Access Report

**Boarding Homes**

1 Station Lane  
PENRITH

For: Station Lane Pty Ltd  
Ref: LP\_21060

Figure 2 | Overall Site Plan

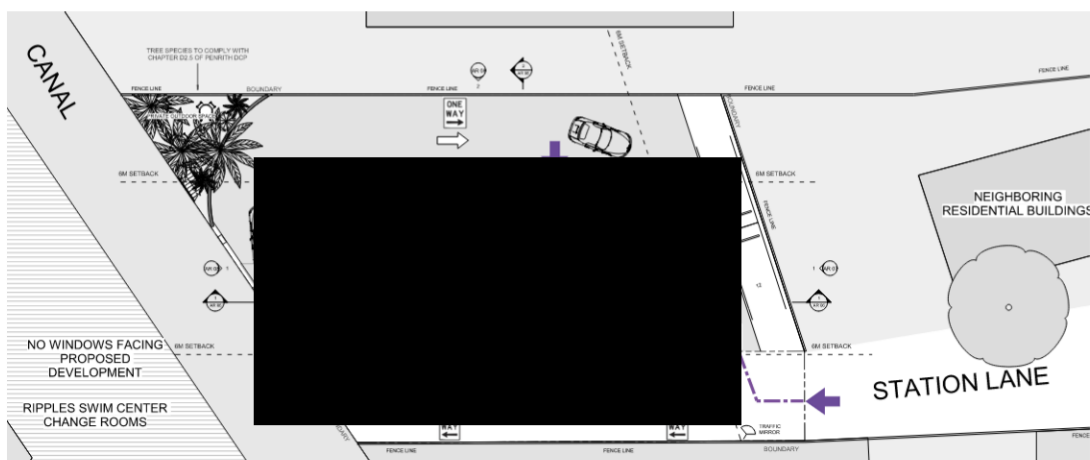
- from the allotment boundary at the pedestrian entrance along Station Lane to the accessible building entrance.
- from the accessible carparking area to the building entrances.

Pedestrian access from Station Lane to the accessible entrance is via the shared vehicular areas that appear to provide a level area.

Level access is provide to eh accessible entrance form the accessible carparking spaces.
